Tech Tip

Blue Bird BBCV (Vision)/GM 8.1L Propane Engine w/single serpentine belt

REVISION "B" – DATE 9-18-12

REVISION “C” – DATE 2/7/2014

Figure #1

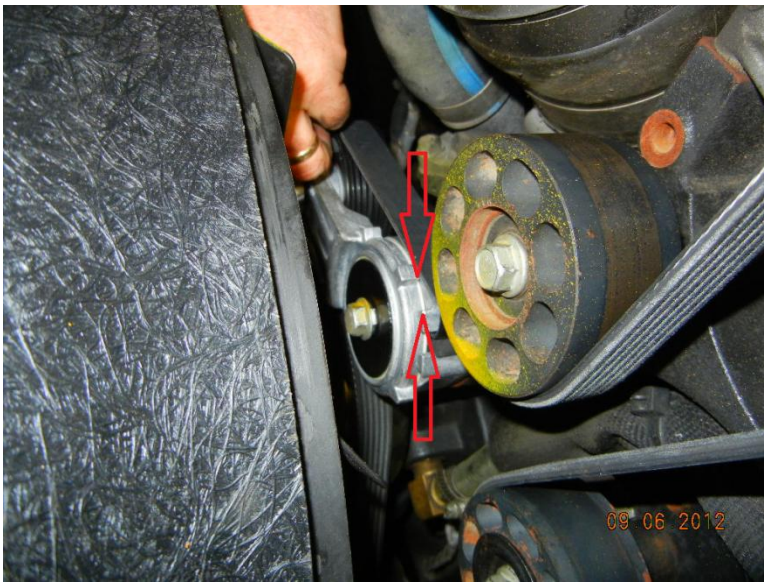
- Complaint –** The belt tensioner nubs are running too close showing that the tensioner +/- or belt are worn. A slight “chirp” may be heard on shutdown of the engine – Please see Figure #1 & 2.
- Cause –** If the belt or the tensioner has recently been replaced it may be the improper part, if not the belt +/- or tensioner may be worn.
- Correction –** If the belt +/- or tensioner have recently been replaced and the “nubs” of the tensioner are still close you need to make sure that the proper parts have been used. See the text box below-

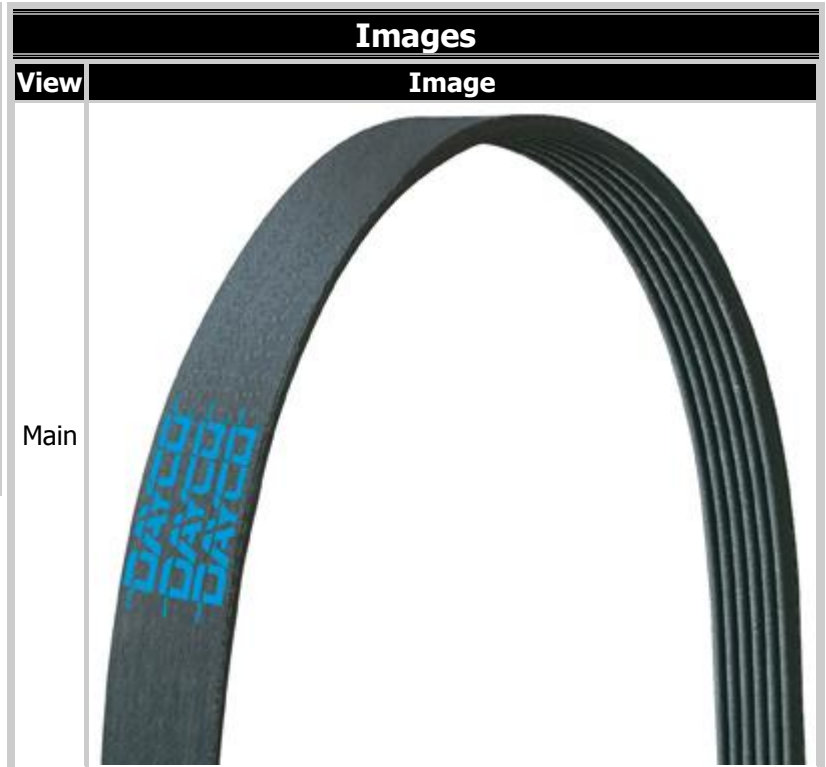
PLEASE NOTE – WE FOUND THAT THERE IS A DIFFERENCE IN BELT MANUFACTURES ALSO AS SHOWN BELOW THE DAYCO SPEC ON THE LENGTH IS 136.02” WHERE THE NAPA BELT WHO IS MADE BY GATES IS 136.5” WHICH COULD EFFECTIVELY CAUSE AN ISSUE WITH THE BELT TENSIONER POSITIONING –THEREFORE IT IS STRESSED THAT OEM PARTS SHOULD BE REPLACED WITH OEM PARTS

Figure #4

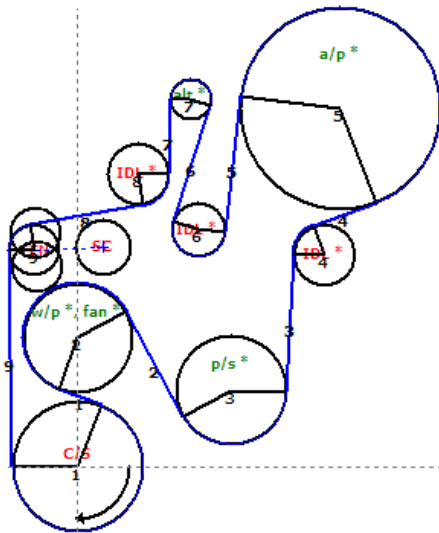
After replacing the belt and tensioner as previously discussed it was determined that the tensioner would again be running too close to the nubs which was not recommended. Working with Dayco it was determined that idler #6 in the **Figure #4** should be replaced with a slightly larger pulley, Dayco #89106. Once this is done and the unit ran for a couple of days you can see that the tensioner is almost perfectly centered as it should be.
